# AQUALLIANCE

April 18, 2024

Re: Revised Colusa Subbasin Groundwater Sustainability Plan

**Figure 1. Subsidence in Agricultural Lands Within the Colusa Subbasin**

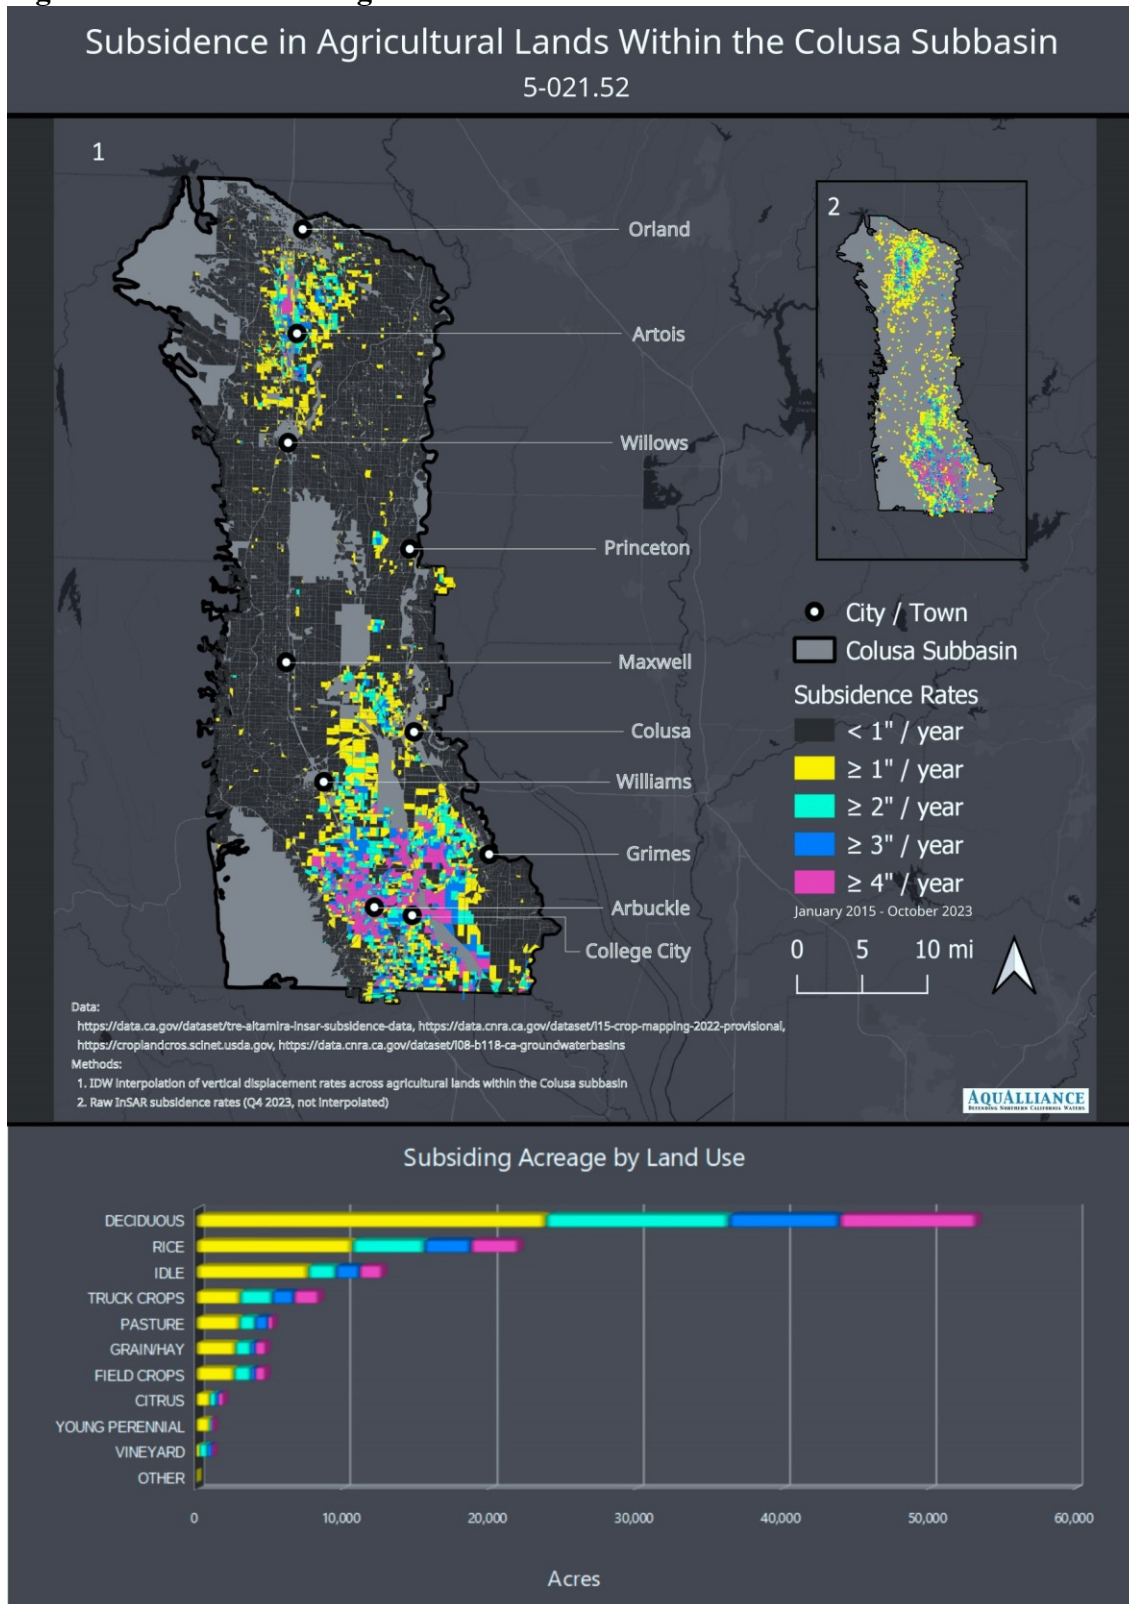
b) Figure 1 clearly illustrates the subsidence in the Colusa Subbasin. How does it compare with the GSP material? As one can see in the magenta areas, the land is collapsing at 4 inches per year, or a foot every three years. Knowing the land uses overlying the subsidence paints an interesting picture. What will the GSAs consider doing to stop the actors causing it?
